UNITED STATES PATENT AND TRADEMARK OFFICE

APPLICATION NO.	FILING DATE	FIRST NAMED INVENTOR	ATTORNEY DOCKET NO.	CONFIRMATION NO.
10/760,324	01/20/2004	Brett Lickle	LKL-100	9784
60612 7590 11/06/2007 MCCARTER & ENGLISH, LLP BASIL S. KRIKELIS Renaissance Centre 405 N. King Street, 8th Floor WILMINGTON, DE 19801			EXAMINER NGUYEN, TAM M	
			ART UNIT 3764	PAPER NUMBER
			MAIL DATE 11/06/2007	DELIVERY MODE PAPER

Office Action Summary

DETAILED ACTION

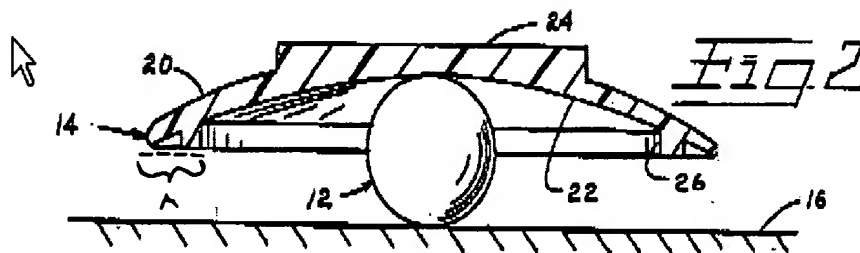
3. Note, Armer also discloses that the lower surface (A) comprises a concave region extending into the board from the lower surface toward the upper surface whereby the apex of the concave region is disposed between the lower surface and the upper surface (see Fig. 2 below).

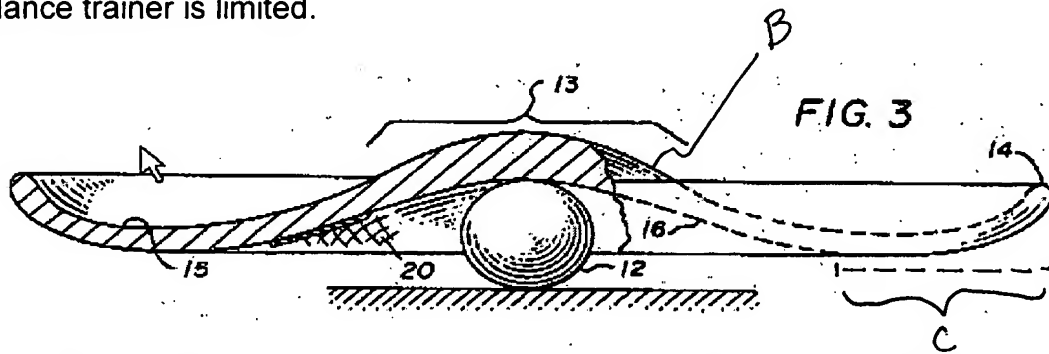
6. As to claims 6, 14, 16 and 17, England discloses a balance training device and inherently a method for exercising as substantially claimed, the device comprising a board (11) and a balance insert (12) wherein the board includes a top surface (B) and a bottom surface (C) having a concave region extending into the board from the lower surface toward the upper surface whereby the apex of the concave region is disposed between the lower surface and the upper surface (see Fig. 3 below). England does not disclose that the trainer further comprises a platform having a concave top surface and a substantially flat bottom surface wherein the balance insert rides on said top surface. Sasser discloses a similar trainer having a platform (42) having a concave top surface (62) and a substantially flat bottom surface (54) wherein a balance insert (34) rides on said top surface (see Figs.3-6). At the time of the invention, it would have been obvious to a person of ordinary skill in the art combine Sasser's platform with England's board
